**CULTURAL RESOURCES OFFICE  
PRESERVATION BOARD  
REGULAR MEETING  
MONDAY FEBRUARY 28<sup>TH</sup>, 2011  
1015 LOCUST ST. #1200  
4:00 P.M.  
<http://stlouis-mo.gov/cultural-resources>**

**PRELIMINARY REVIEWS**

SITE PLAN

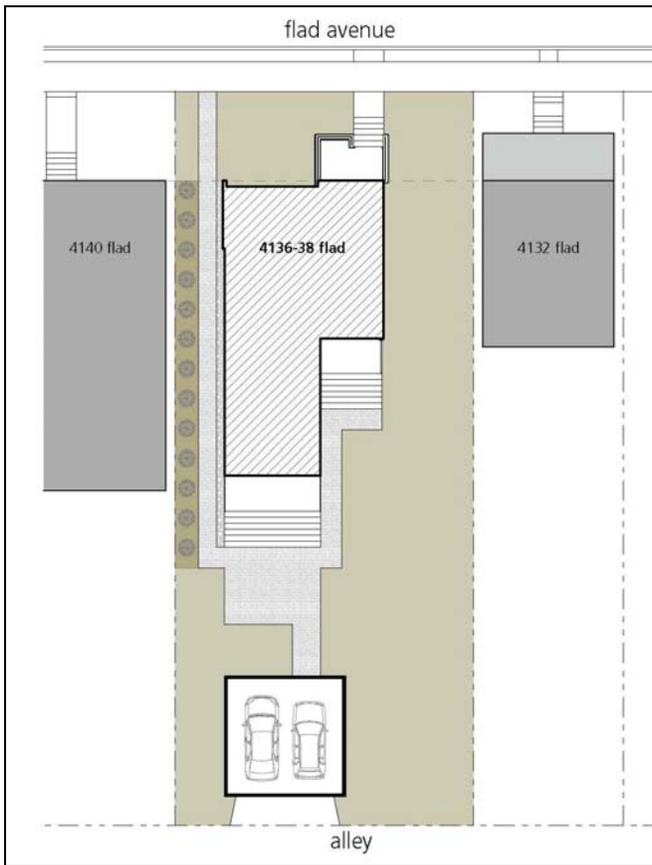
**Appears to comply.** The site plan indicates a two-car garage directly behind the house with entry from the alley.

FIRST FLOOR PLAN

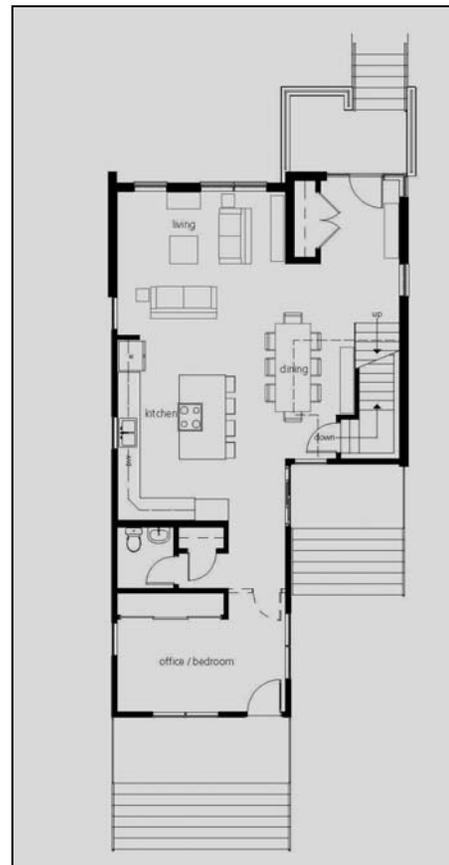
**Partly complies.** The building adheres to the front building line and the projection of the entry bay and stoop is no deeper than historic porch examples. However, the widths of the side yards, most particularly the eastern one, are considerably larger than is characteristic of the block. And while there are a number of different property types with varying widths on the street, the proposed design is wider than single or two-family buildings and narrower than four-family flats. In conjunction with the unusual widths of the side yards, this will disturb the spatial rhythm of this fairly cohesive streetscape.

**WEST ELEVATION**

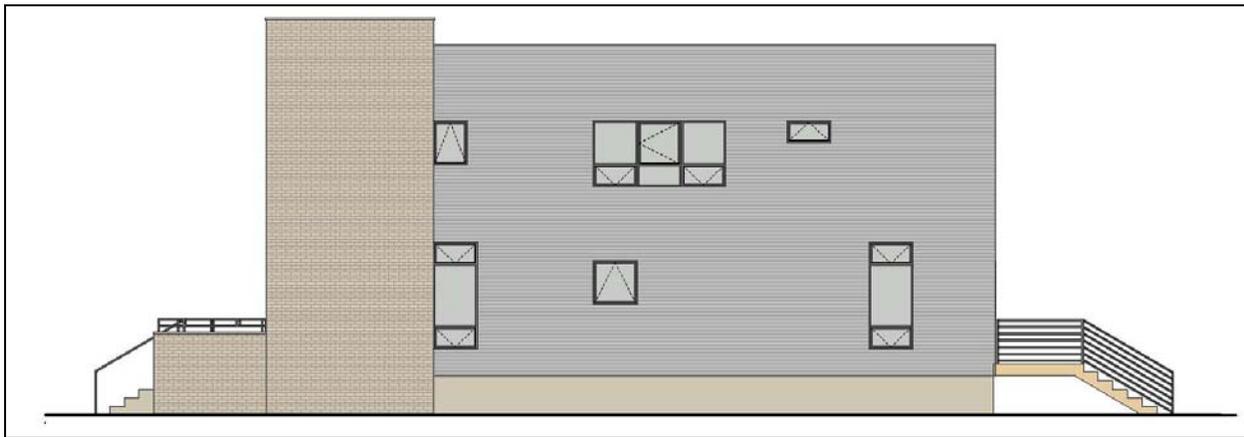
**Does not comply.** Window and door sizes, method of opening, height to width proportions and their arrangement on the building’s facades are not characteristic or compatible with adjacent historic buildings. Those are defined by doublehung windows recessed into the plane of the wall; projecting cornice lines; and elaboration of the façade with water tables and other decorative devices. The proposed design presents a much flatter appearance and the size of the windows in proportion to the scale of the front elevation is far greater. While the house will have a flat roof as do the majority of buildings on the street, there is no articulation of a cornice line as is seen on every other building. In addition, the projecting stoop does not reproduce the massing of the projecting porches on the block. These porches are important elements that often carry a majority of front facade detail.

The staff would like to see the front elevation a single color — or two shades that are closer in color and tone — and either narrowed to be more in proportion with the 2-family buildings on the west, or widened to conform with the larger four-families on the block. The large front windows should be doublehung, or at least reduced in size and in height to reflect the proportions of historic windows; and arranged in symmetrical bays, as is characteristic of the historic buildings in the District. We understand that pre-cast lintels and sills have been added to the windows at the request of the neighborhood; we would also recommend an additional design element at the front parapet that conveys the impression of a cornice.

REAR FAÇADE

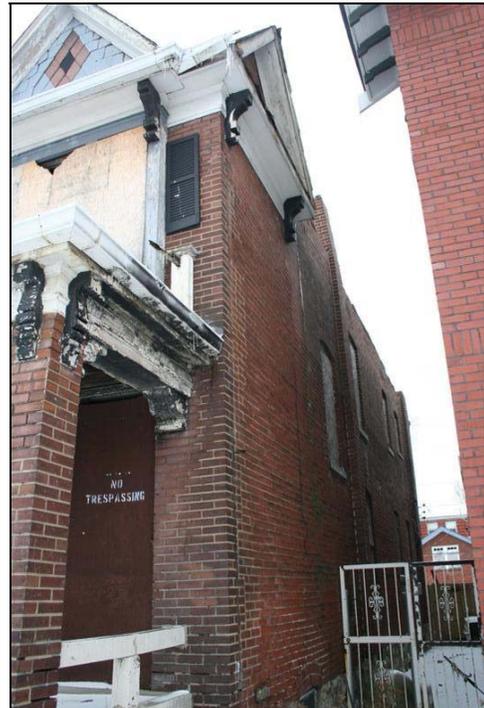
The three walls of the brick shell appear to be in salvageable condition, the rear wall of the house suggests the extent of the damage to the house and the rear foundation.

1903 SANBORN MAP OF ST. LOUIS LEAD & OIL CO.  
Area within box to be demolished

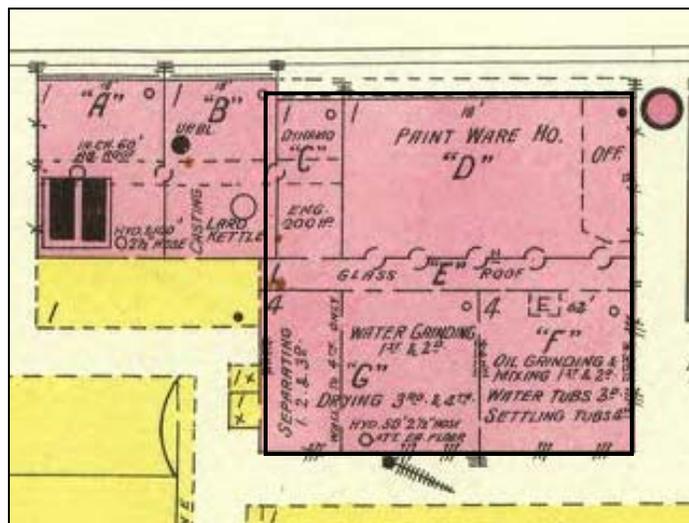
**The St. Louis Lead & Oil Company began developing the plant site on Manchester Avenue in 1890, the year before the local firm became part of the National Lead Co. The 1903 Sanborn map documents the earliest buildings on the site, including the complex of attached brick buildings, a portion of which is proposed for demolition. The plant was expanded significantly during the 1910s with unit construction reinforced-concrete buildings. Permits issued in 1910 covered alterations to both the 4-story building and the adjacent one-story warehouse. At that time it appears that a reinforced-concrete column and floor girder system was built within the 4-story building that was used as a vertically-oriented production facility. This building has brick enclosing walls rising above raised stone foundation. Segmentally-arched windows are filled with multi-light sash of a**

variety of materials. Pilasters rise through the gable faces with bull's-eye vent openings. The Sanborn map shows the hallway that separates the ground floor of the 4-story building from the adjacent one, a space that survives. A second story was added to the warehouse building north of the 4-story one. The 2-story building has wide door openings facing the loading platform and flat-arched windows on the second story.
